# **As-Built Baseline Monitoring Report**

Rough Horn Swamp Restoration Site Monitoring Year – MY00 2020 DMS Site ID Number 97005 DMS Contract 6596 SAW-2015-00952 and NCDEQ DWR 2015-0903

Rough Horn Swamp II Restoration Site DMS Site ID Number 100053 DMS Contract 7514 SAW-2016-02026 and NCDEQ DWR 2015-0903

Date:	May 12, 2020
To:	Kelly Phillips, DMS Project Manager
From:	Adam Spiller, Project Manager
	KCI Associates of North Carolina, PA
Subject:	MY-00 Monitoring Report Comments
-	Rough Horn Swamp DMS #97005, Contract 6596
	Rough Horn Swamp II DMS #100053, Contract 7514

CURRENT CONDITIONS PLANVIEW ROUGH HORN SWAMP RESTORATION SITE & ROUGH HORN SWAMP II RESTORATION SITE COLUMBUS COUNTY, NC

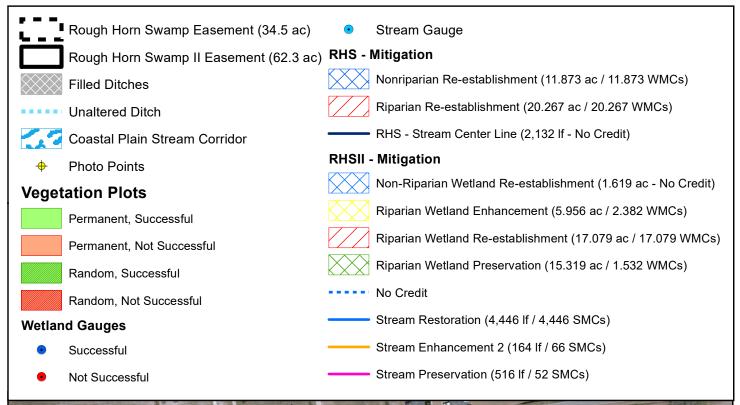
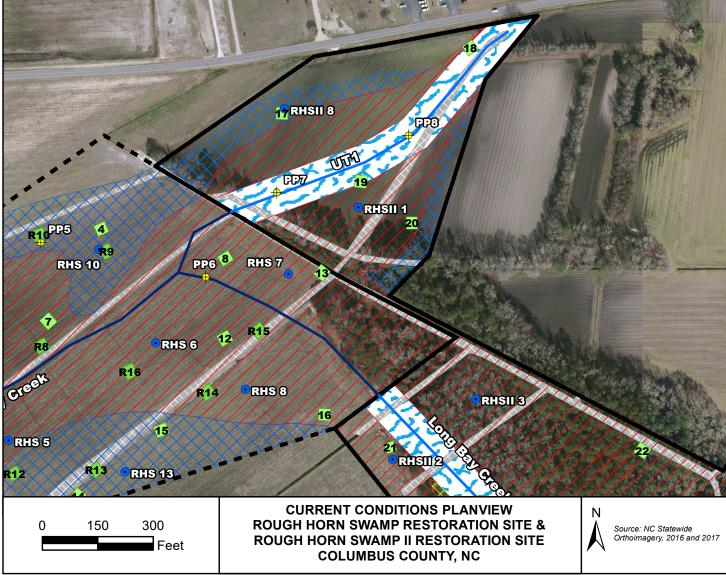
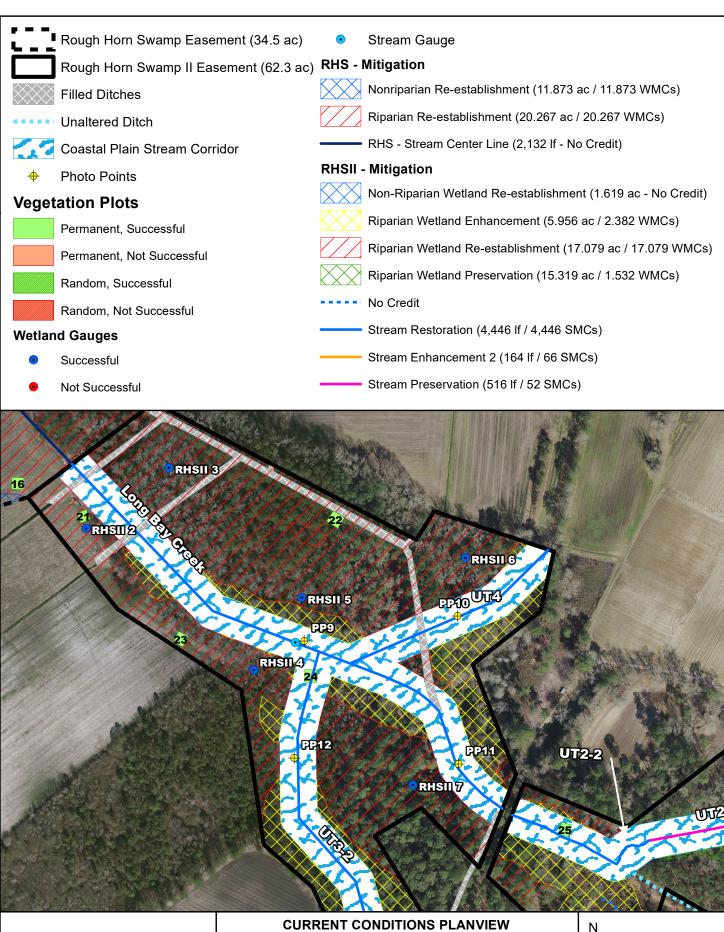
- 5. Differentiate vegetation plots on CCPV to show permanent and random/temporary and move them in GIS to show all as visible on CCPV. *KCI Response: This change has been made.*

# **As-built Plan Sheet**

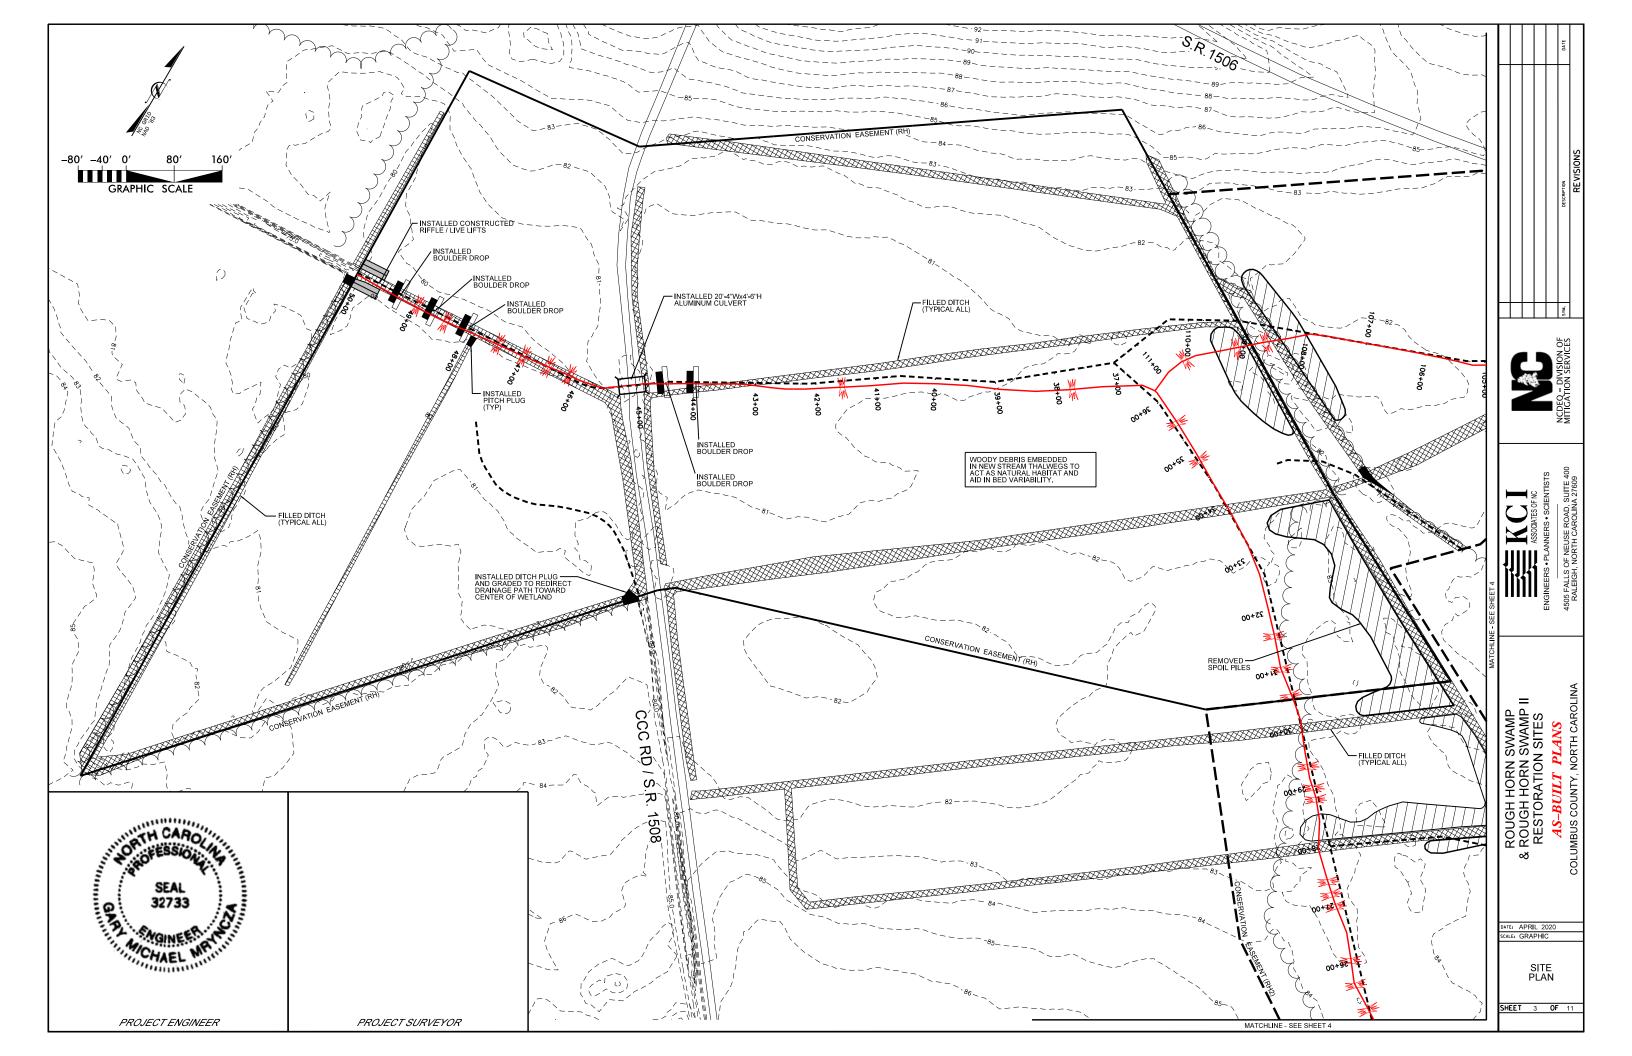
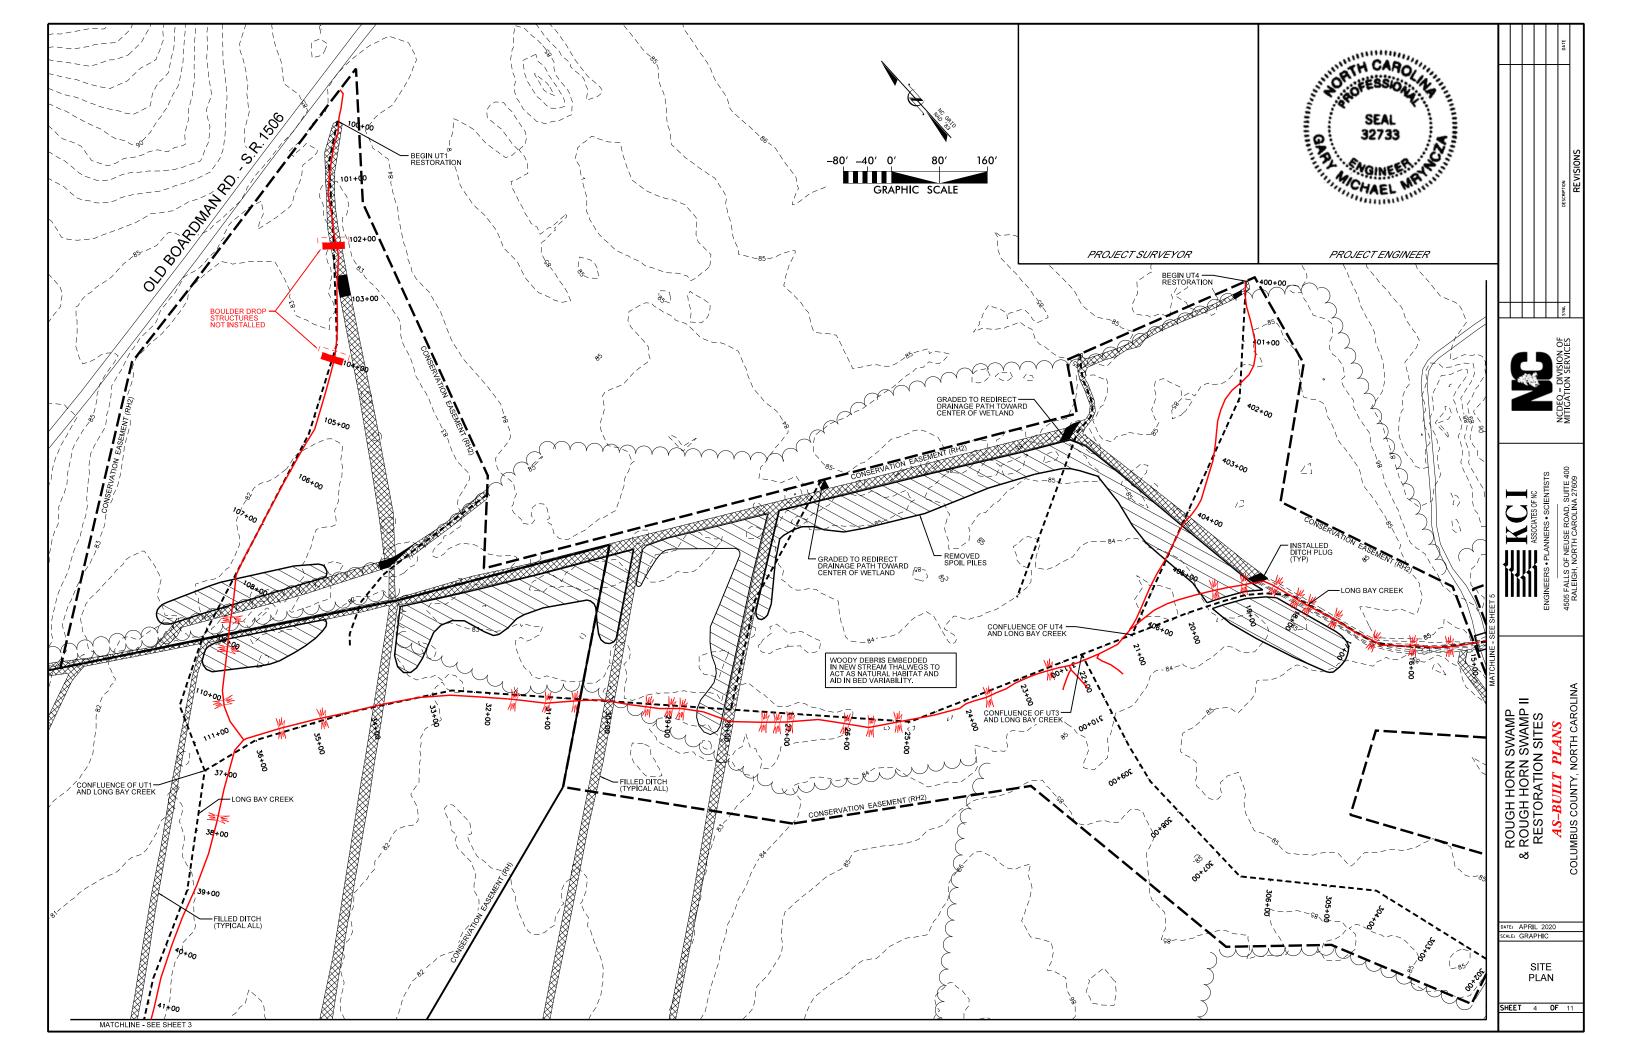
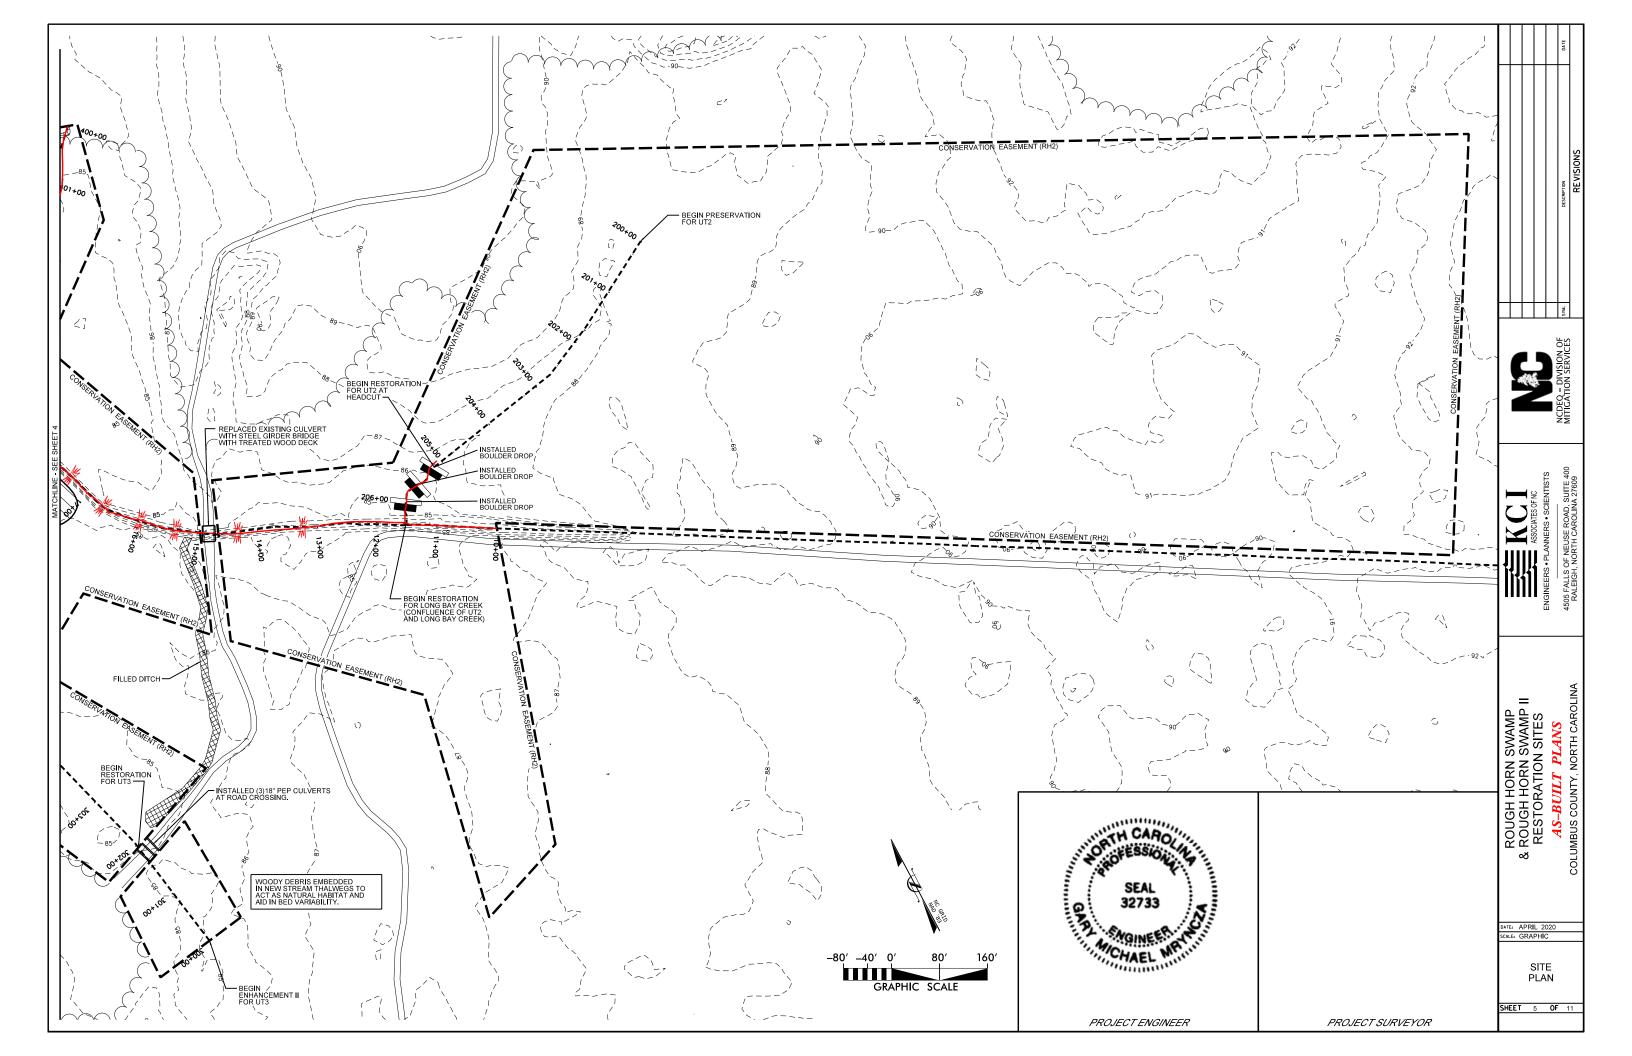
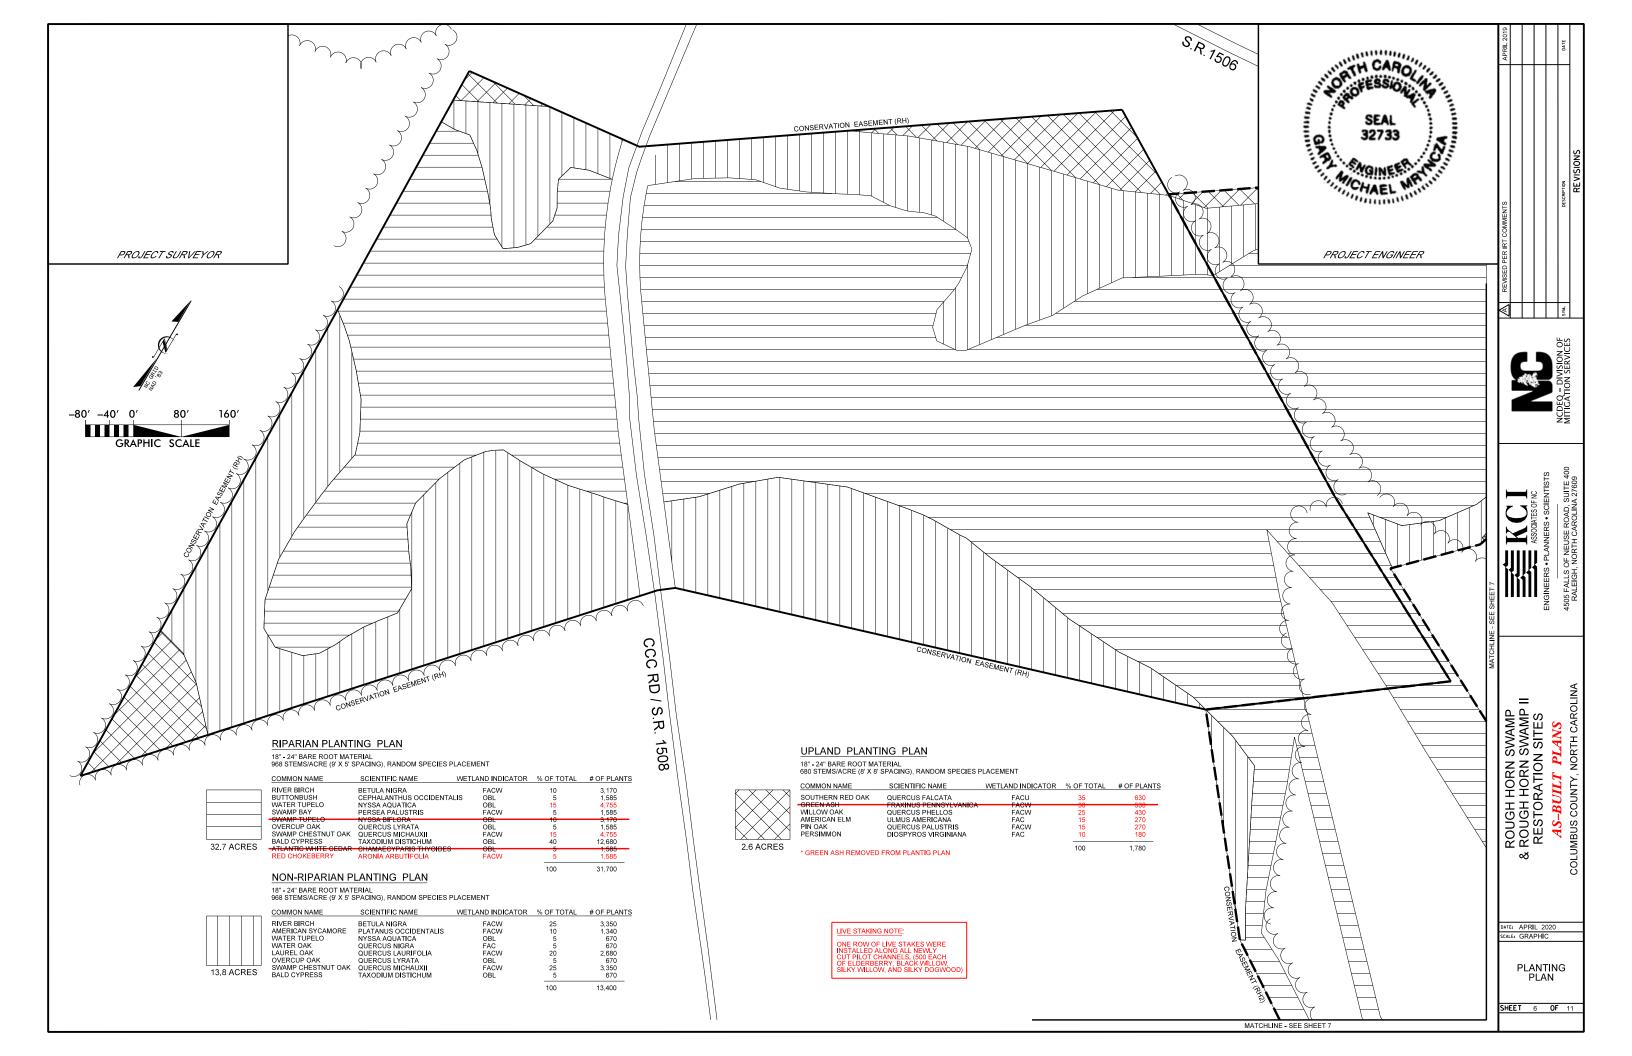
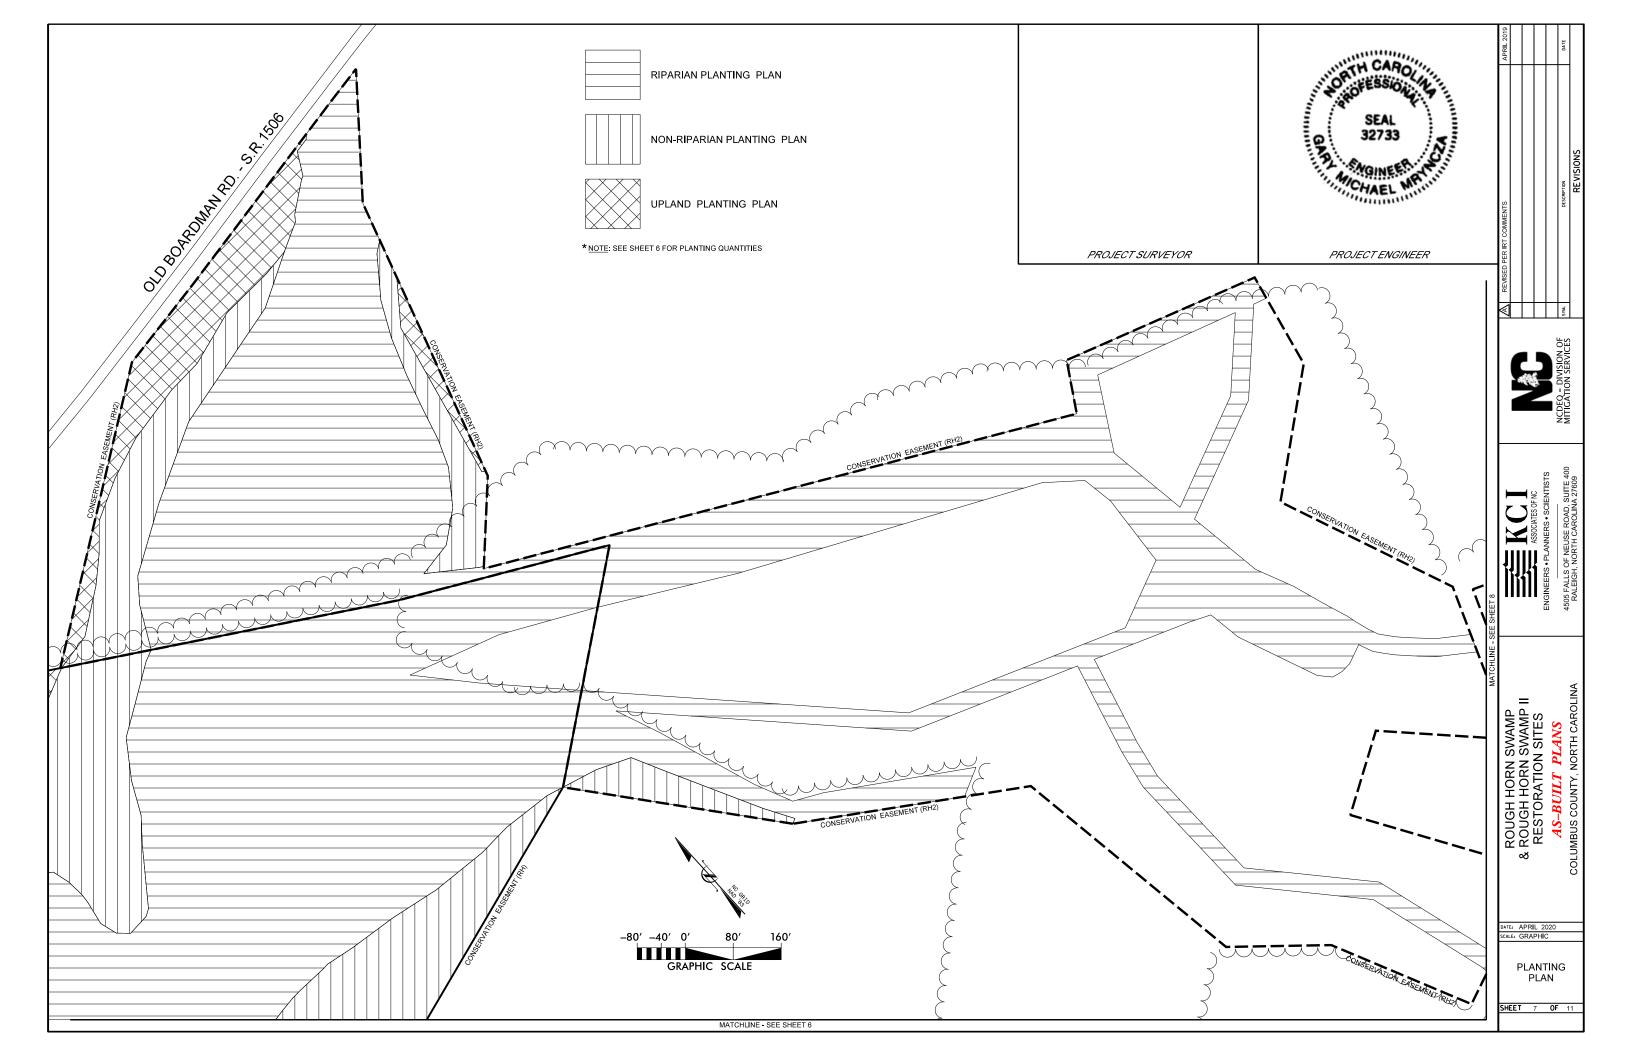
- 9. Provide justification why the ditch plugs were not shown on as-built plans. DMS observed that the ditch plugs were installed, but that layer was not on drawings. *KCI Response: Ditch plugs were inadvertently left off of the as-built plans. This error has been corrected.*

- Check the labels of topo on the As-Builts. There were some instances in the field where the label did not appear to make sense for the topo line. *KCI Response: Additional topo labels have been added to the as-built plans to clarify the elevations* of the topo lines.
